UNITED STATES
NUCLEAR REGULATORY COMMISSION

VIRGIL C. SUMMER NUCLEAR STATION, UNIT NO. 1

AMENDMENT TO FACILITY OPERATING LICENSE

Amendment No. 133
License No. NPF-12

Figure 3.4-3 V. C. Summer Unit 1 Reactor Coolant System Cooldown (Cooldown rates up to 100°F/hr) Limitations Applicable for the First 13 EFPY (With Margins 10°F and 60 psig For Instrumentation Errors)

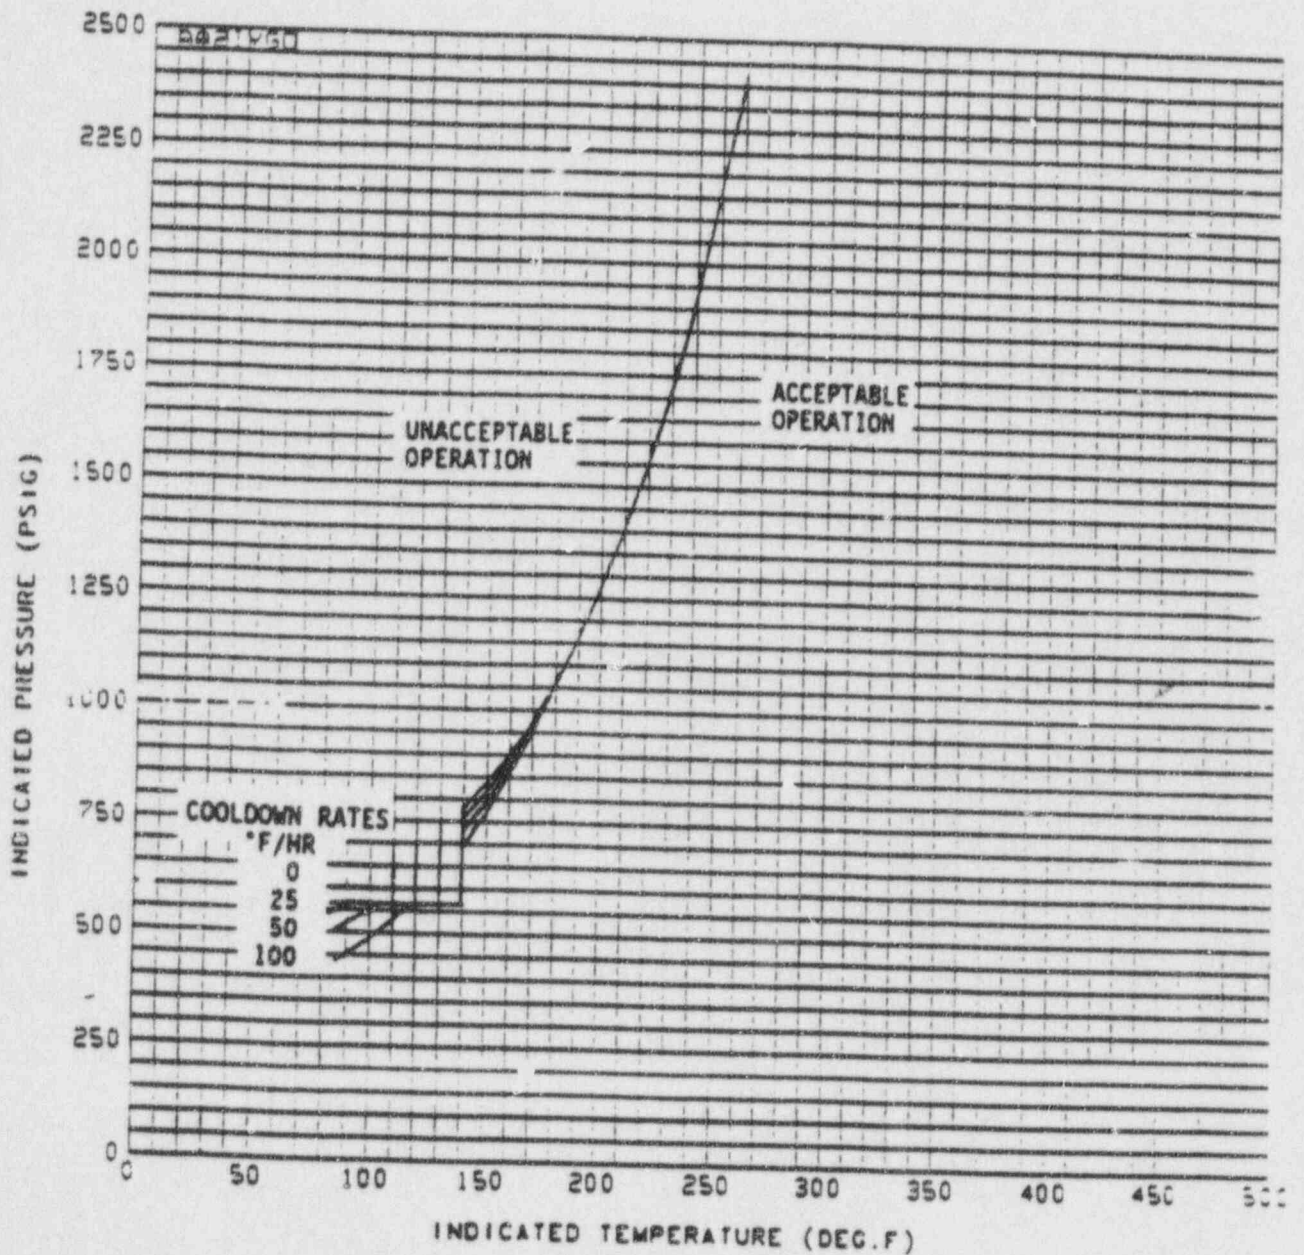
CONTROLLING MATERIAL: LOWER SHELL
INITIAL RT_{NDT}: 10°F
ART AFTER 13 EFPY: 1/4T, 96°F
3/4T, 83°F
